# STATE OF OHIO DEPARTMENT OF TRANSPORTATION

## DEF-24-11.35

CONSTRUCT A NEW 0.42 MILE 2-LANE OVERPASS AT THE US24/CR 185 AT-GRADE INTERSECTION & REMOVE CURRENT INTERSECTION. THE PROJECT CONSISTS OF RAISING CR 185 OVER US24 ON THE EXISTING ALIGNMENT, CONSTRUCTING A NEW 2-SPAN BRIDGE & REMOVING INTERSECTION PAVEMENT ON US 24 & RESTORING US 24 TO A 4-LANE DIVIDED FACILITY.

ADDENDUM	NUMBER	DATE	DESCRIPTION
	1	02/14/2025	UPDATED DATE

**DRAINAGE DETAIL US 24**  
**STA. 842+60 TO STA. 848+20**

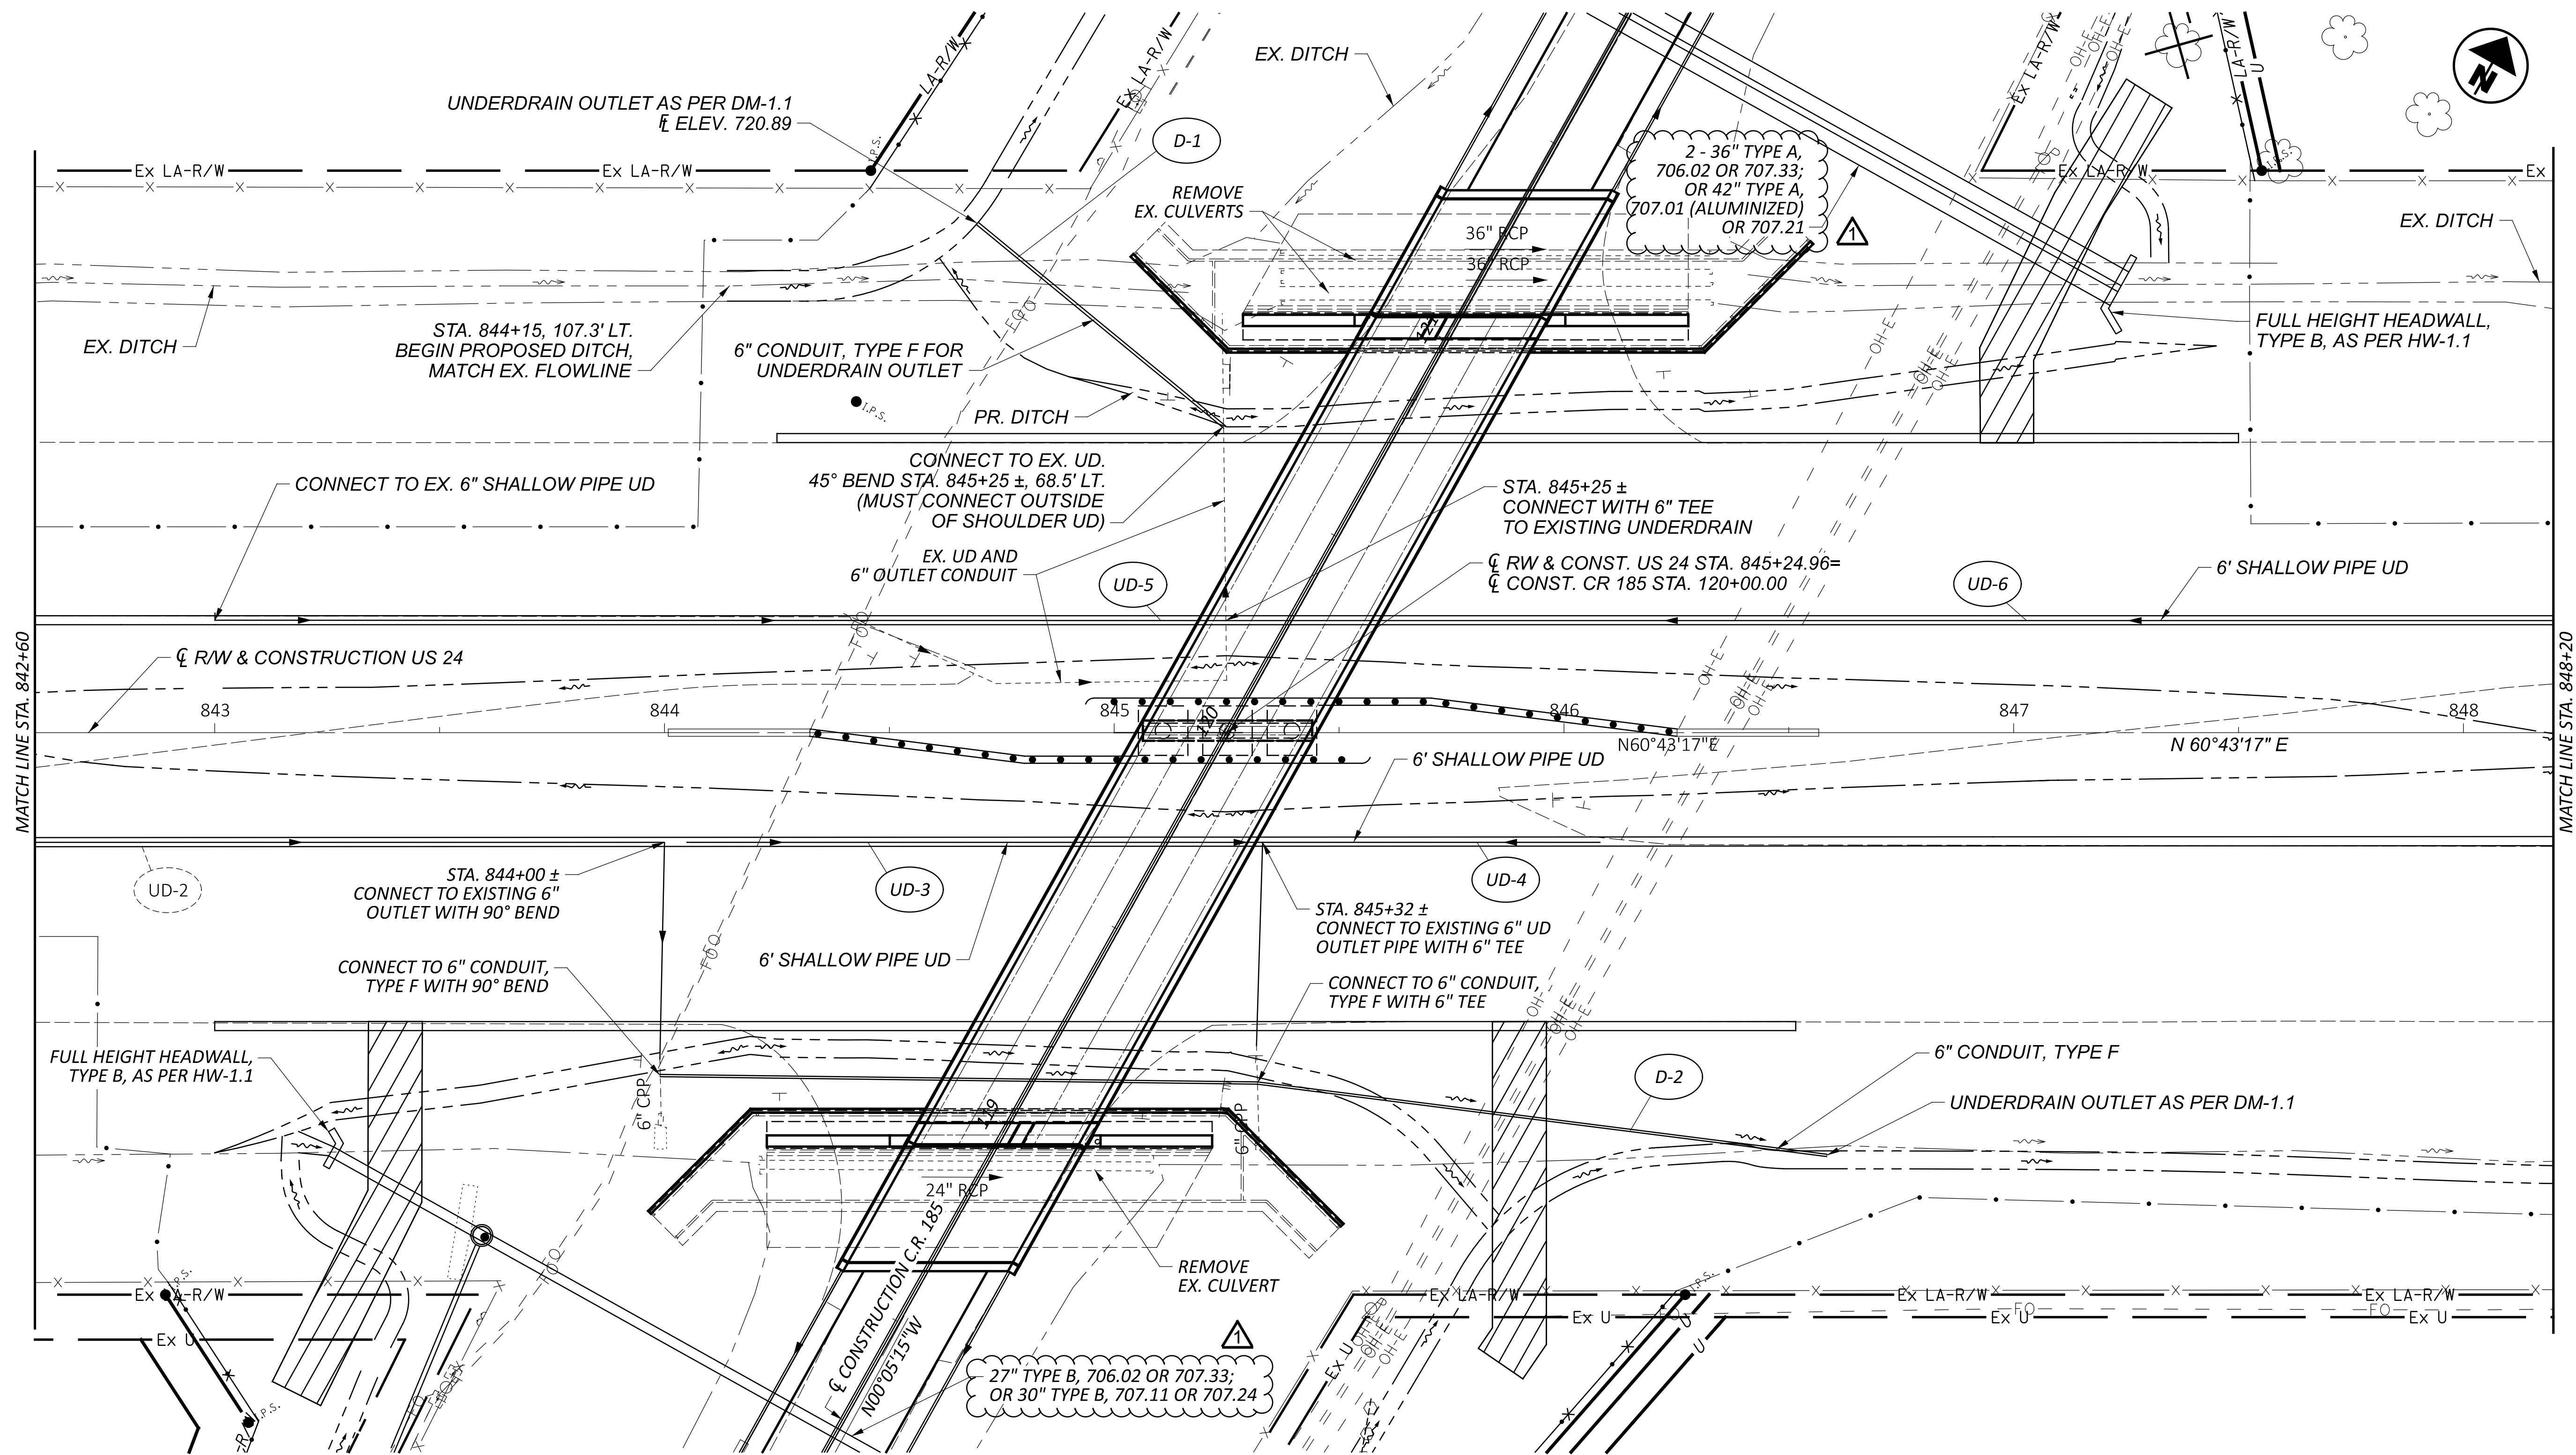
ADDENDUM	NUMBER	DATE	DESCRIPTION
▲		02/14/2025	REVISED CALLOUTS

DRAINAGE DETAIL CR 185  
 STA. 113+00 TO STA. 118+60

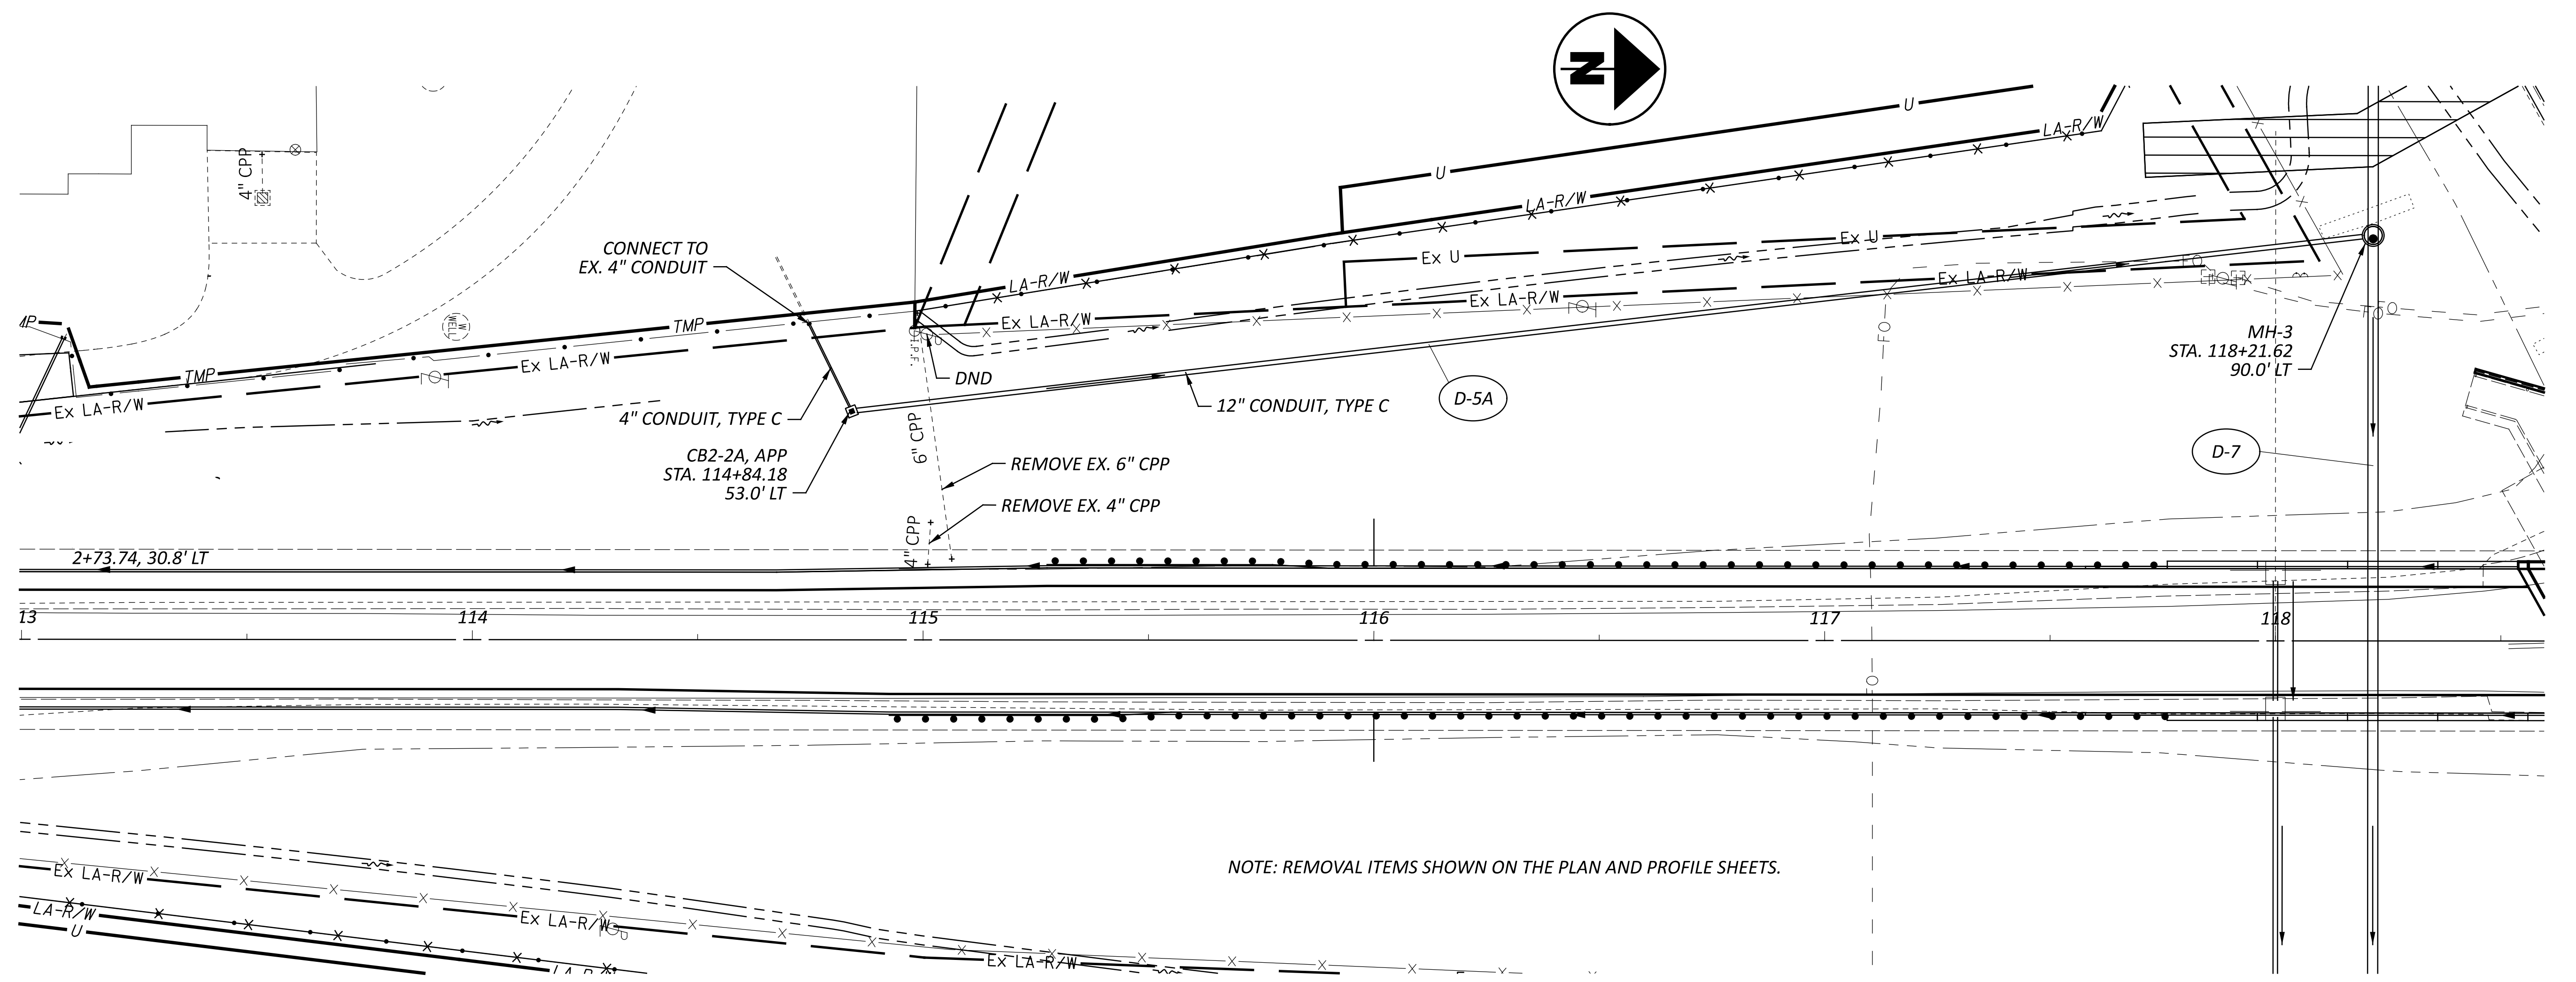
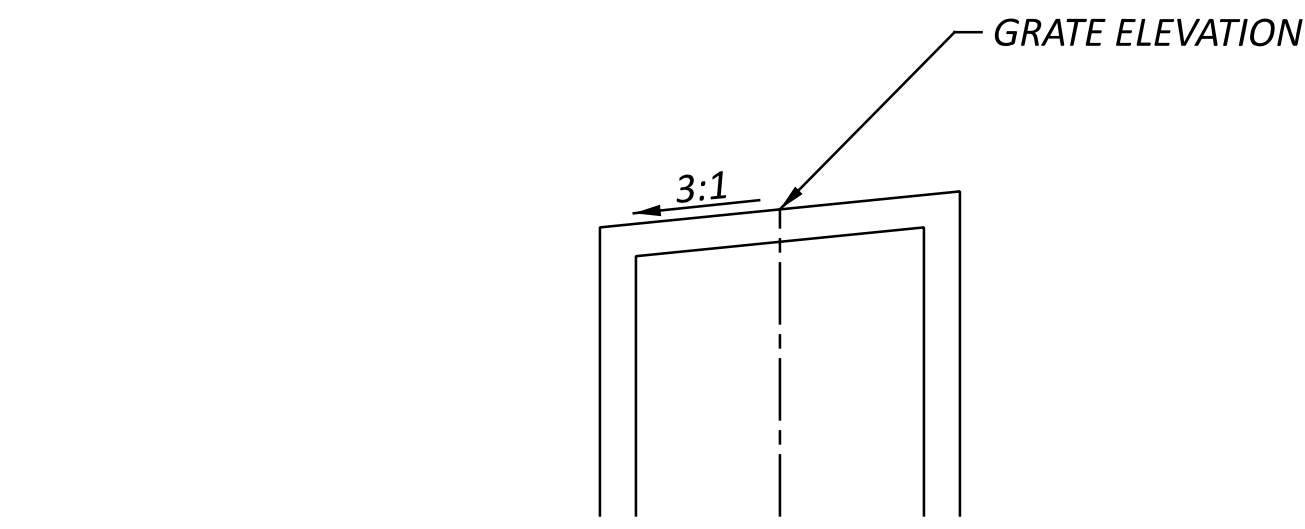
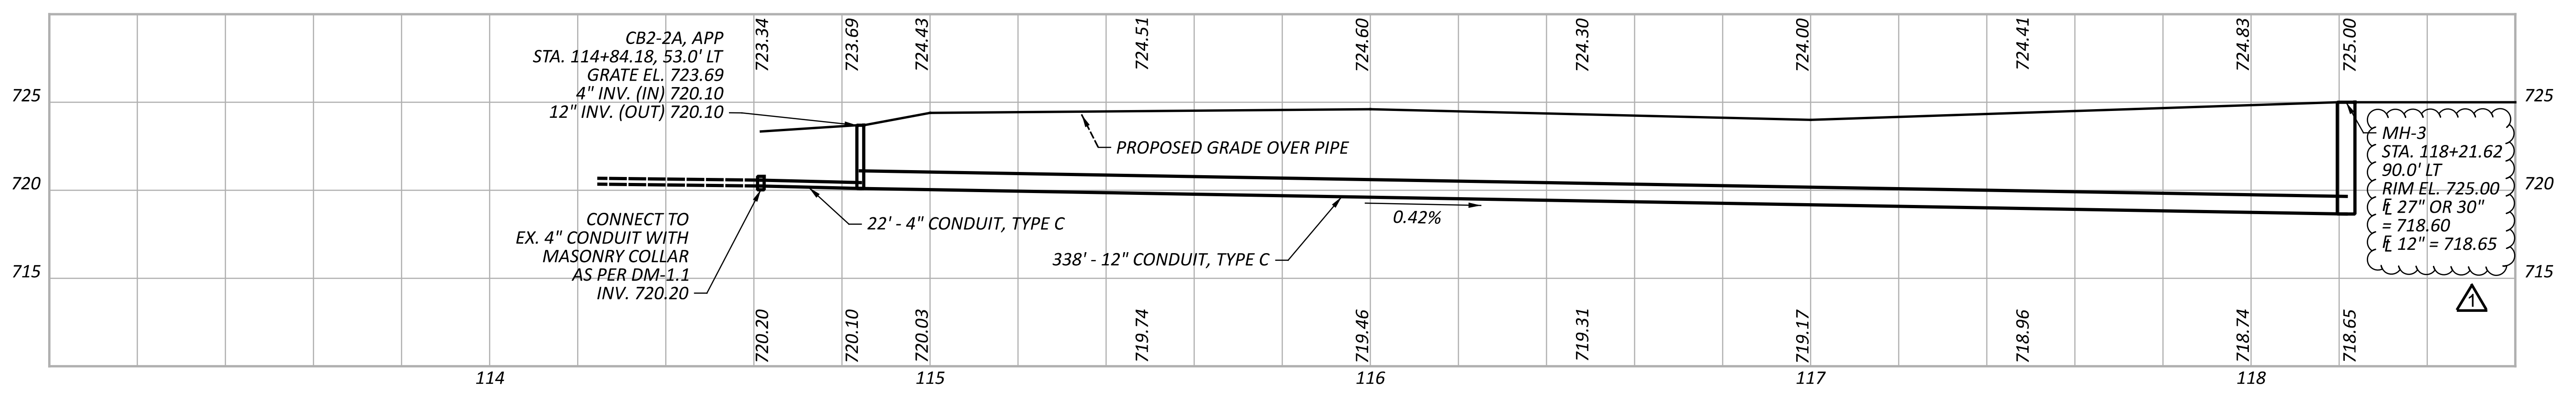
GRATE DETAIL AT CB2-2A, APP AT STA. 114+84.18

ADDENDUM	NUMBER	DATE	DESCRIPTION
▲		02/14/2025	REVISED CALLOUT

**SETTLEMENT PLATFORM NOT TO SCALE**

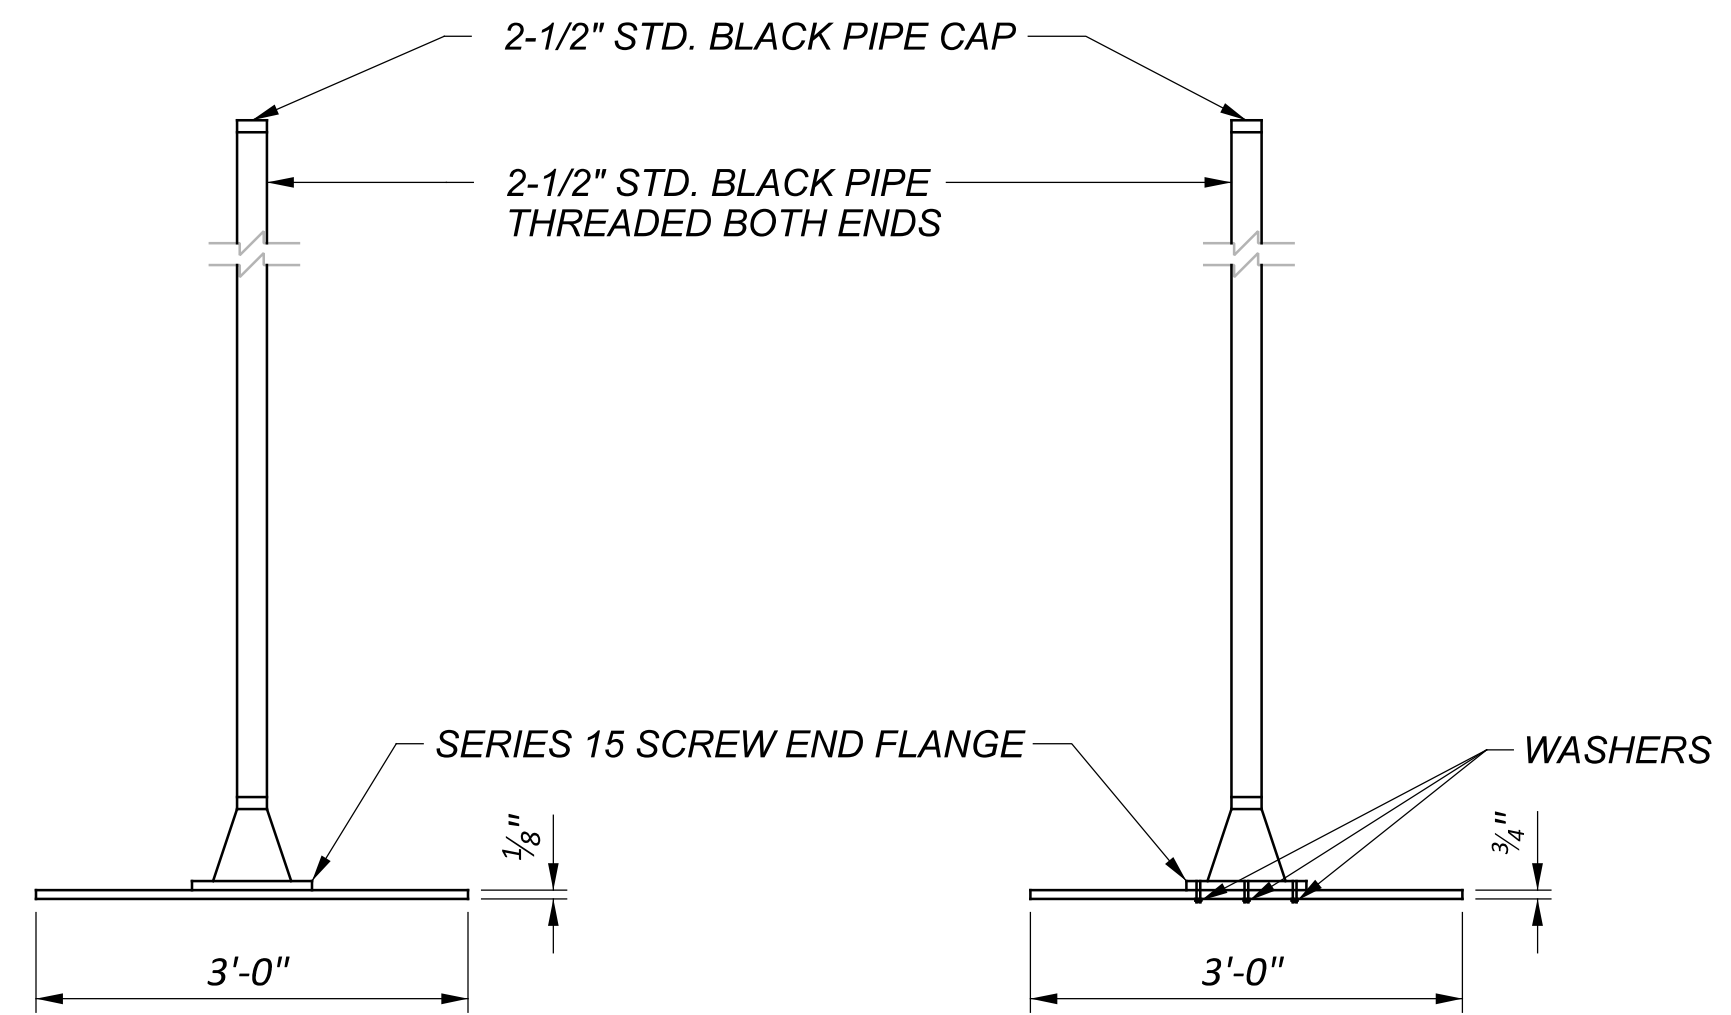
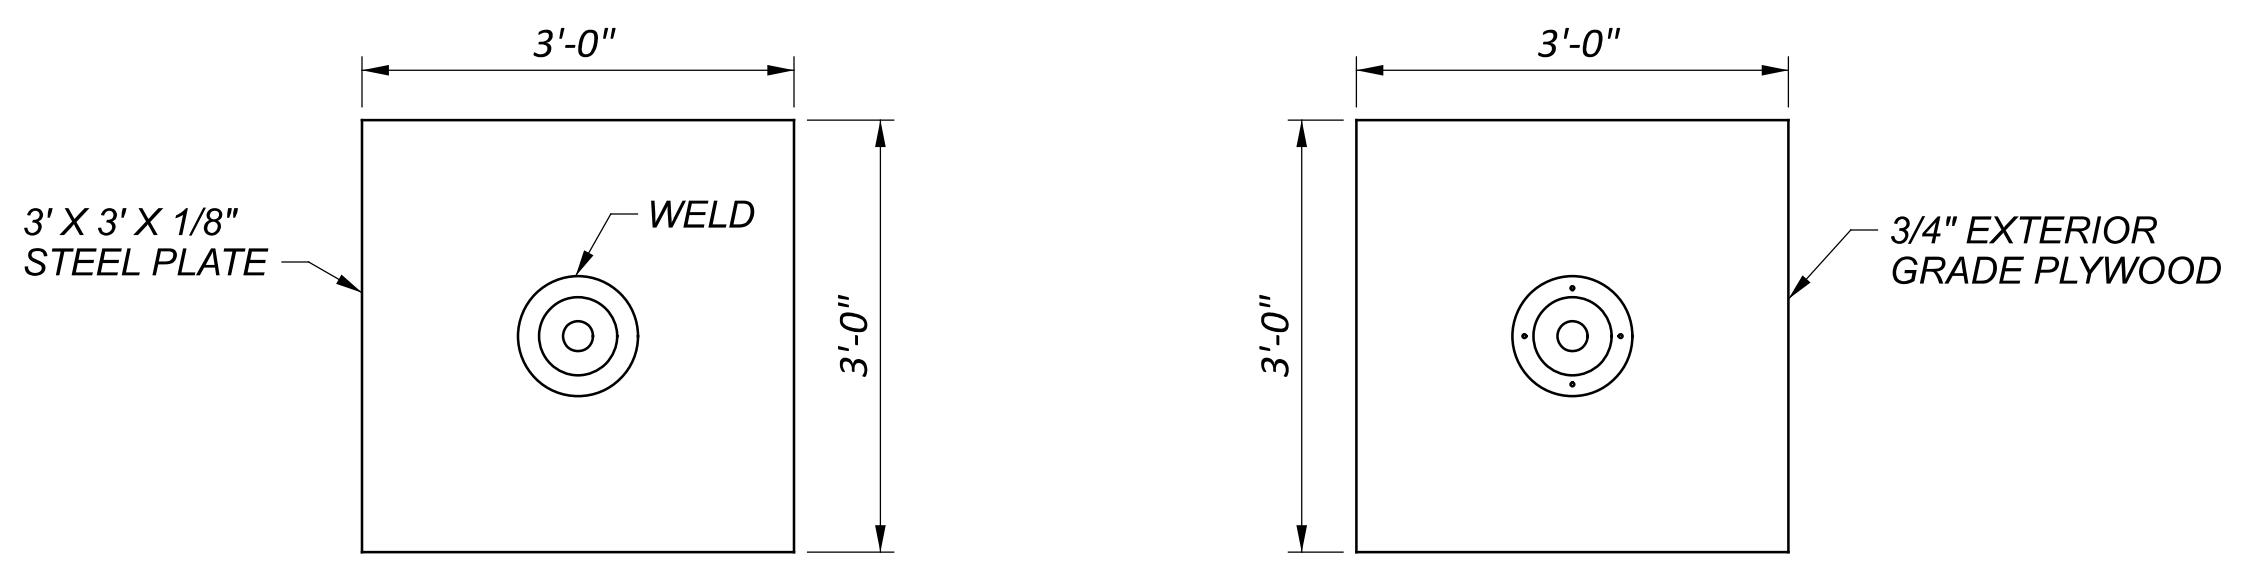
THE ESTIMATED SETTLEMENT IS 1.44 INCHES. THE ESTIMATED SETTLEMENT PERIOD IS 8 CONSECUTIVE DAYS AFTER THE FINAL LIFT OF EMBANKMENT HAS BEEN PLACED.

ADDENDUM	NUMBER	DATE	DESCRIPTION
	▲	02/14/2025	REVISED NOTE
